Historic Preservation Design Review

HP-14-14, 21 N. Main St. – Opera House Façade Windows (City)

Request: Design Review for replacement of windows on façade of Sumter Opera House.

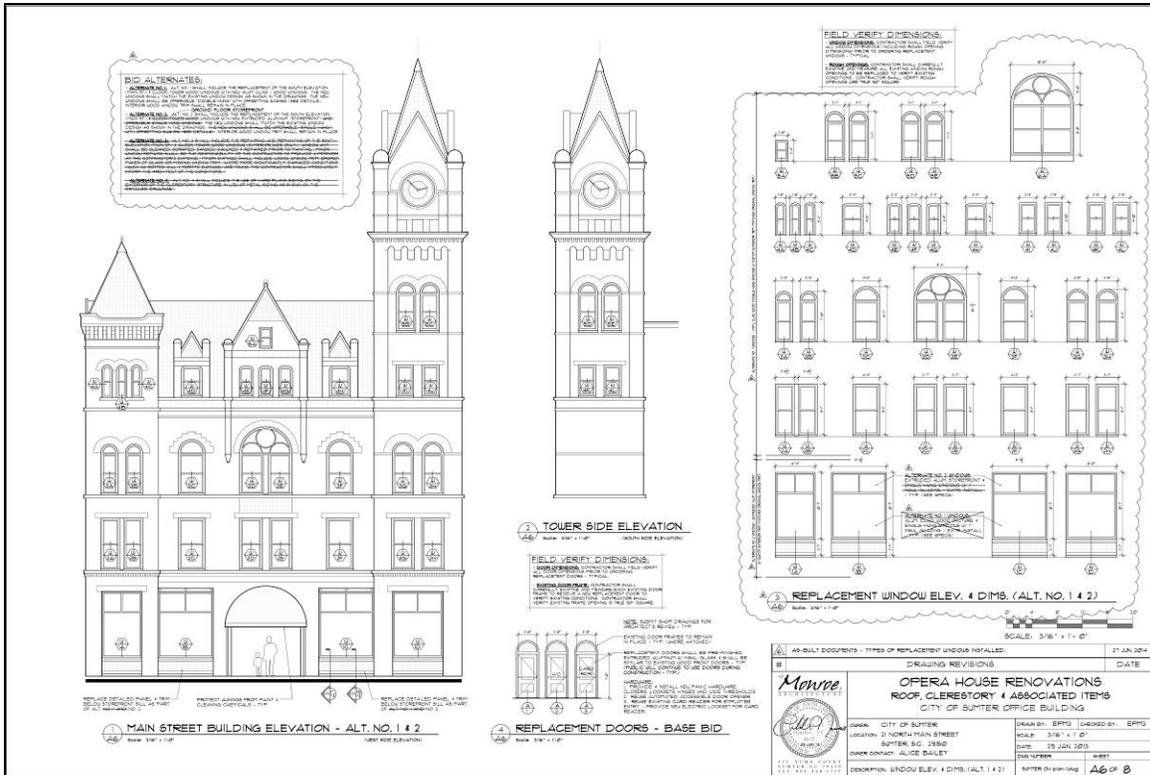
The scope of work, as shown above, included the replacement of 4 first-floor storefront sill windows and 29 upper façade windows of varying sizes, some with rounded transoms.

The replacement windows are wooden clad double-hung and were custom made to match the original windows' configurations.

Staff recommends approval of this request. The proposed project generally meets the requirements set forth in the design review guidelines. The previous windows on the Opera House were deteriorating, and great effort was made by the City to use the highest quality replacement windows, that matched the originals in both design and materials.

The Sumter Historic Preservation Design Review Committee at its meeting on Thursday, August 28, 2014 voted to approve this request for design review approval for replacement windows on the façade of the Sumter Opera House in accordance with plans, materials and colors submitted based on compliance with criteria #s 13 and 38 of the *Design Review Guidelines*.
